P-05-278

Supplement 1 January 2008

Forsmark site investigation

Drilling of monitoring wells HFM23 and HFM28 at drill site DS9 as well as HFM24 and SFM0080 at drill site DS10

Technical data Borehole HFM23

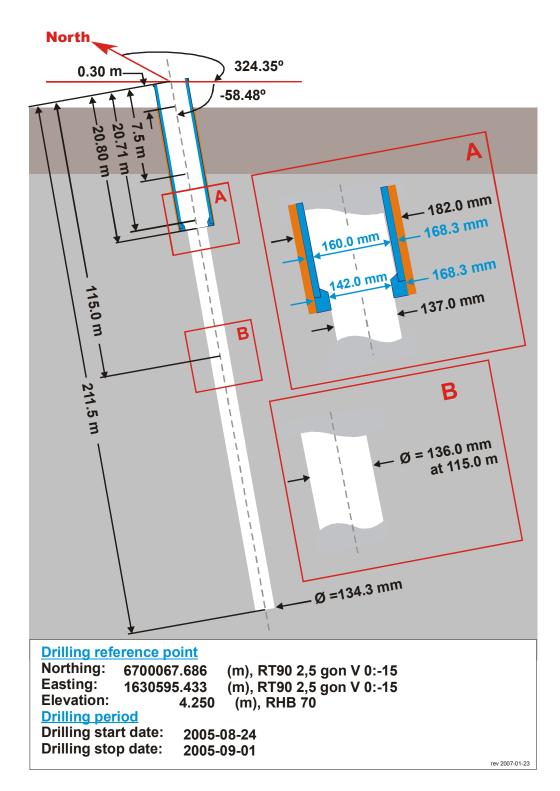
A new version of Figure 5-1 shows that the final borehole diameter is 0.1343 mm, which value should be changed also in Table 5-1. The adjustment is also made in Sicada. The casing length above ground surface is 0.30 m.
